# UNITED STATES PATENT AND TRADEMARK OFFICE

APPLICATION NO.	FILING DATE	FIRST NAMED INVENTOR	ATTORNEY DOCKET NO.	CONFIRMATION NO.
10/579,194	05/12/2006	Moo-Seok Lee	3254-0137PUS1	6707
2292 7590 04/09/2009 BIRCH STEWART KOLASCH & BIRCH PO BOX 747 FALLS CHURCH, VA 22040-0747				
EXAMINER MENON, KRISHNAN S				
ART UNIT 1797		PAPER NUMBER		
NOTIFICATION DATE 04/09/2009		DELIVERY MODE ELECTRONIC

# Office Action Summary

### DETAILED ACTION

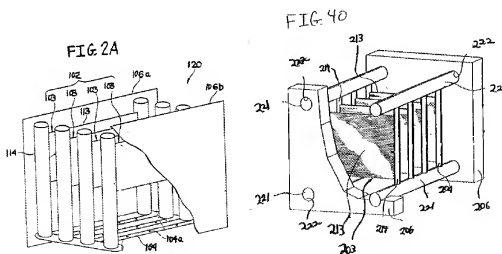
Claims 1-11 are provisionally rejected on the ground of nonstatutory obviousness-type double patenting as being unpatentable over claims 1-13 of copending Application No. 10/593,480. Although the conflicting claims are not identical, they are not patentably distinct from each other because claims of the reference application recites all the limitations of the instant claims

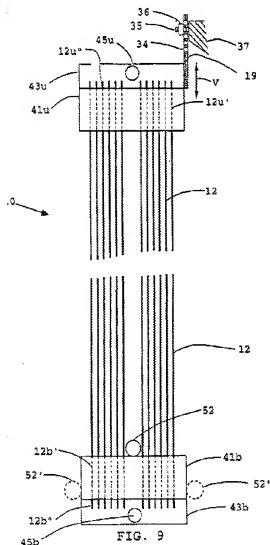
**Cote** teaches a swinging air distribution system for a submerged membrane unit – see figures. The air distribution system is in the form of a frame with two horizontal and two vertical members, and has air supply inlet 42 and distribution holes 50 on the

tubular frame - see fig 3. Air holes are sized with variable sizes for proper distribution and the reference also provides some guidelines for sizing the holes - see paragraph 0047. The swing in the aerator assures that air is blown in all directions – see fig 5.
